Planning Commission Meeting

7:00 P.M. on Tuesday, March 26, 2013

PLANNING COMMISSION STAFF REPORT

Subject: Two-Story Addition at 428 Zinfandel Circle
Site Plan Review Permit (SPR 02-13)

1 PROPOSED LEFT ELEVATION-WEST
SCALE 1/8" = 1'-0"

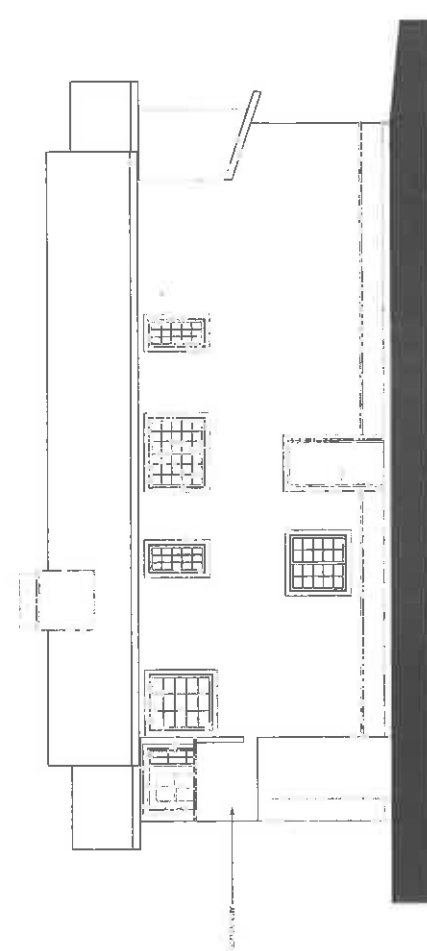
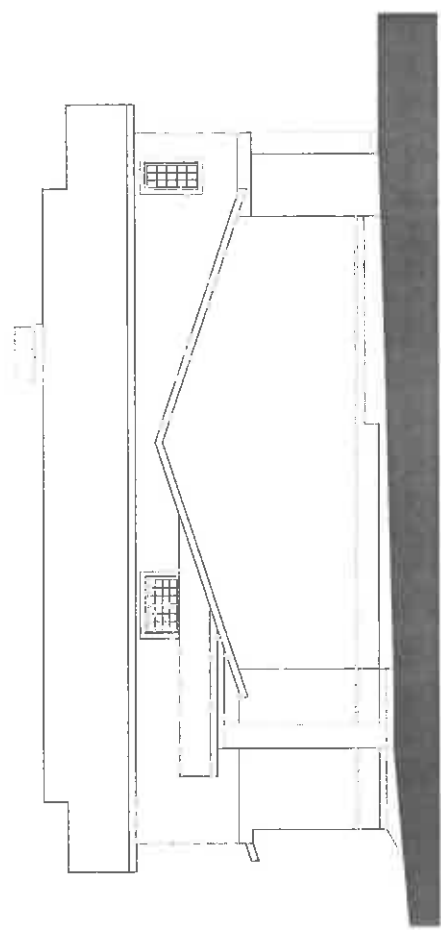
- Option C
The modifications listed in Option B above, as well as alterations to the windows on the second story of the left (west) side elevation of the residence; specifically, the proposed window on the left elevation over the tub in the master bathroom. Reduction of privacy impacts may be attained through use of opaque materials to allow light into the interior spaces but to obscure views through the window as well as requiring a reduction in the area of the window (i.e., a minimum sill height of six feet or more above the floor), in accordance with Title 24 regulations.
